UNITED STATES PATENT AND TRADEMARK OFFICE

10/779,683

Office Action Summary

DETAILED ACTION

FIG. 3

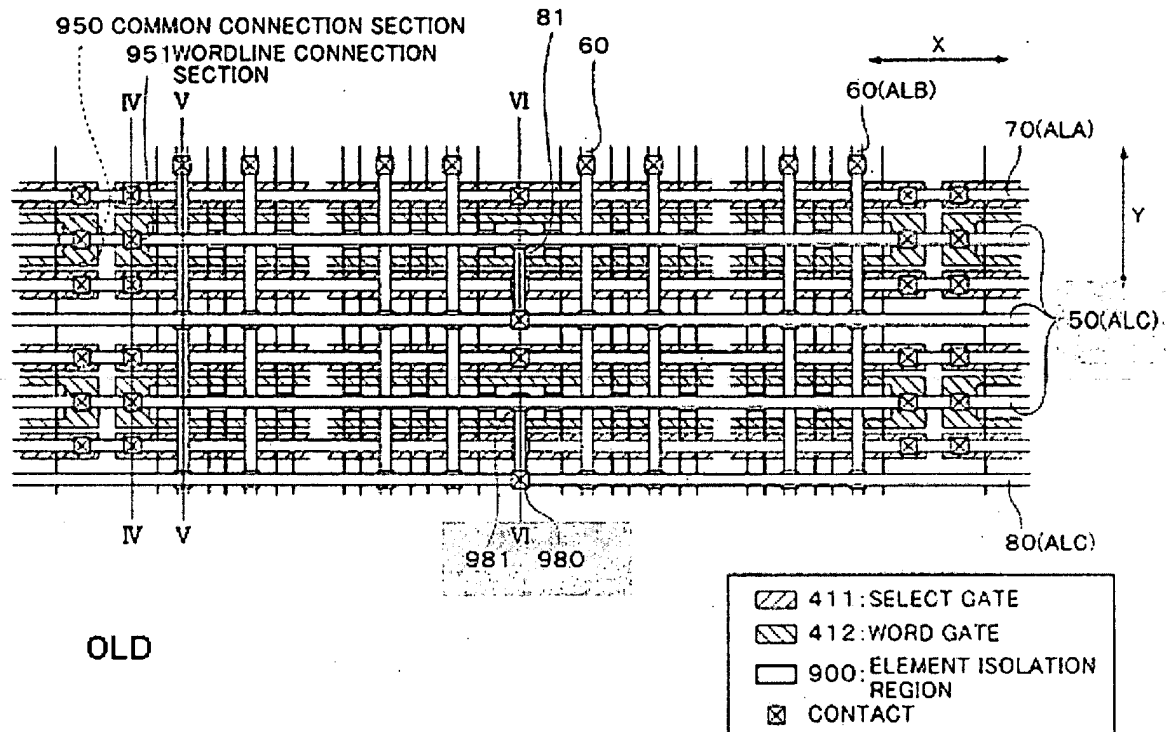
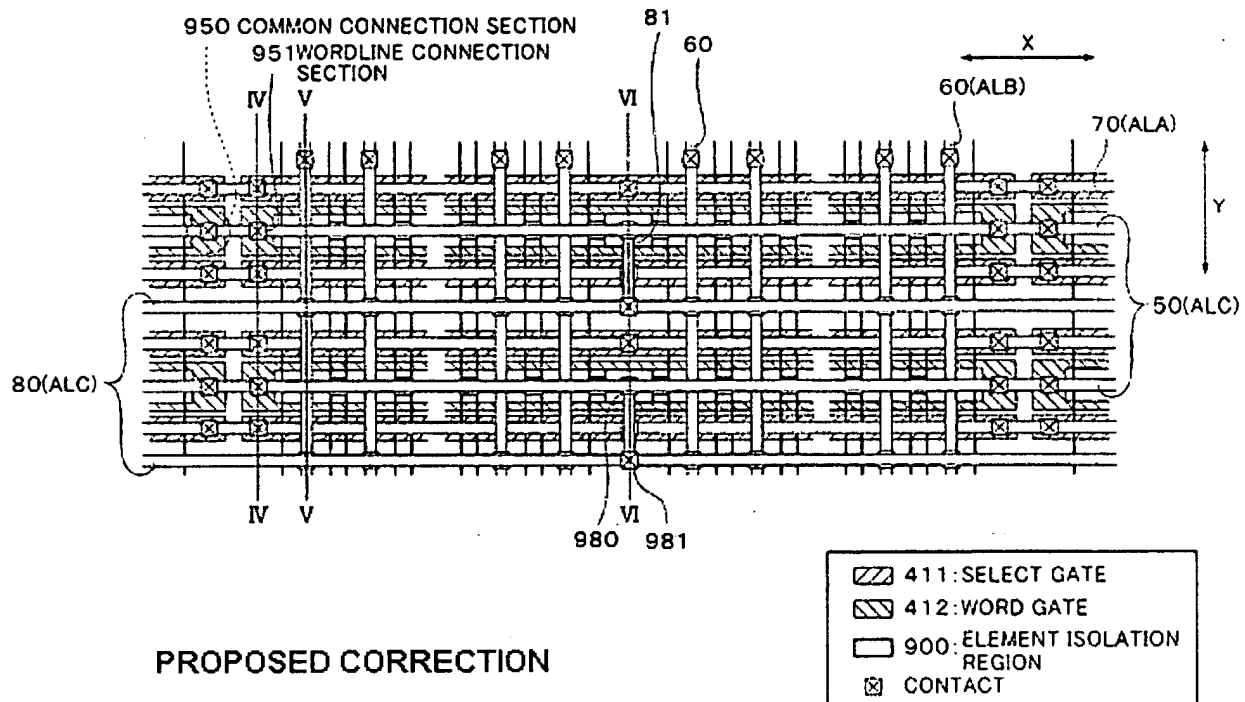
5. The proposed drawings corrections (Fig. 3) received on February 1, 2006 are not approved by Examiner.
6. The drawings are objected to as failing to comply with 37 CFR 1.84(p)(4) because three lines extend to 50, of which two are correct; but, the middle extended line should be deleted. Examiner assumes that applicant intended this line on Figure 3 to be labeled "80." Also, it appears that the orientation of "980" and "981" are reversed (see Fig. 3 with respect to Fig. 6).

For clarity purposes, Examiner provides the following proposed correction to Figure 3 (reversing order of 980 and 981; and correcting line 50):

PROPOSED CORRECTION

Corrected drawing sheets in compliance with 37 CFR 1.121(d) are required in reply to the Office action to avoid abandonment of the application. Any amended replacement drawing sheet should include all of the figures appearing on the immediate prior version of the sheet, even if only one figure is being amended. Each drawing sheet submitted after the filing date of an application must be labeled in the top margin as either "Replacement Sheet" or "New Sheet" pursuant to 37 CFR 1.121(d). If the changes are not accepted by the examiner, the applicant will be notified and informed of any required corrective action in the next Office action. The objection to the drawings will not be held in abeyance.
